Project Name:	Land at Bayards, Eastergate (Miller Homes)
Document Reference:	091.5016/SVR/4.2
Document Name:	SuDS Verification Report – Area 4
Prepared By:	Samuel Flesher
Checked By:	Meagan Weedon
Approved By:	Jon Soar

- 1.1 This Sustainable urban Drainage Strategy (SuDS) Verification Report – Area 4, has been prepared by Paul Basham Associates on behalf of Miller Homes to support the 'As-Built' verification report to Arun District Council in relation to Land at Bayards, Eastergate.

Figure 3: SDS GEOLight Cross Section

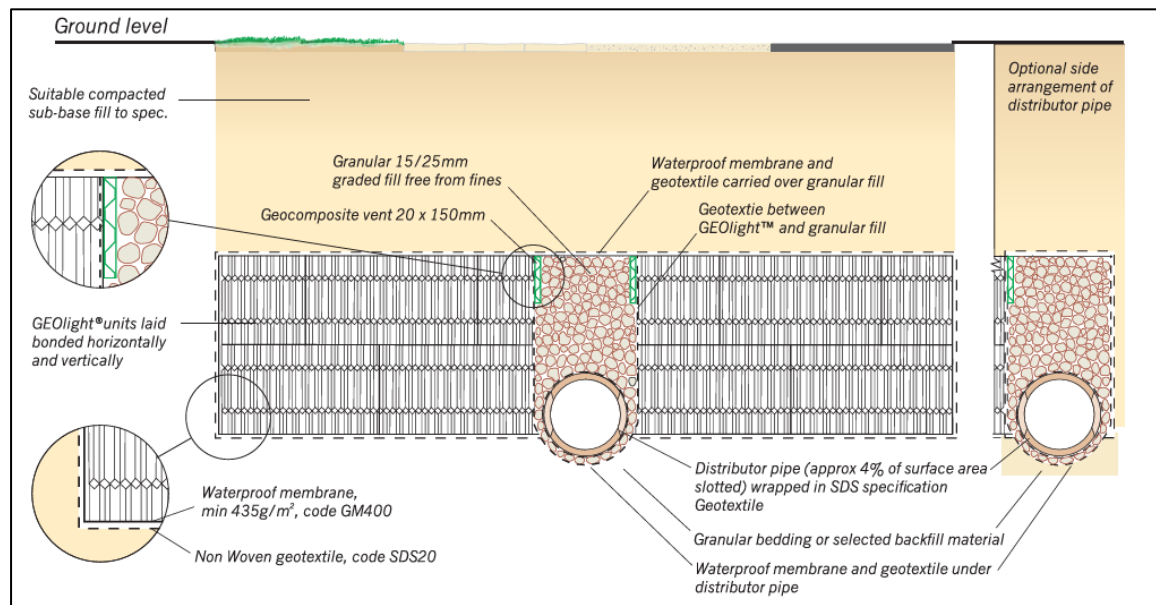
- 4.9 The soakaways have shown an arrangement that differs from the design outlined within the construction detail on sheet 091.5061.551 C01.
- 4.10 The SDS GEOLight system appears to have been substituted and installed in this area. This product typically requires a specific arrangement, including a perforated pipe running centrally through the attenuation crates, as illustrated in **Figure 3** below.

- However, the contractor has instead installed an in-situ pipe that has been hand-cut with spiral slits to function as a perforated pipe, intended to feed water into the crates. This pipe appears to have been installed without appropriate bedding.

- Furthermore, the structural integrity of the pipe has likely been compromised due to the hand-cut slits, which is also evident from the CCTV footage. There also appears to be no restraint preventing the pipe from shifting or rotating. As a result, there is no assurance that the slits will remain correctly oriented (i.e. facing downward towards the crates).

- This may lead to ineffective interaction between the pipe and the attenuation system, potentially causing the drainage to perform in an unintended and unpredictable manner.

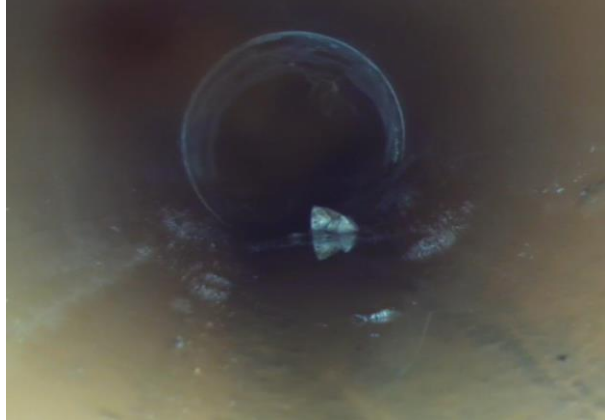
- 4.11 The images also suggest that vents have not been installed in line with the construction detail on sheet 091.5061.551 C01 and in accordance with manufactures specifications which can be found in **Appendix D**.
- 4.12 No images have been provided of SA Road 3 or any of the permeable paving within this area therefore, we are unable to verify this element on the absence of this evidence.
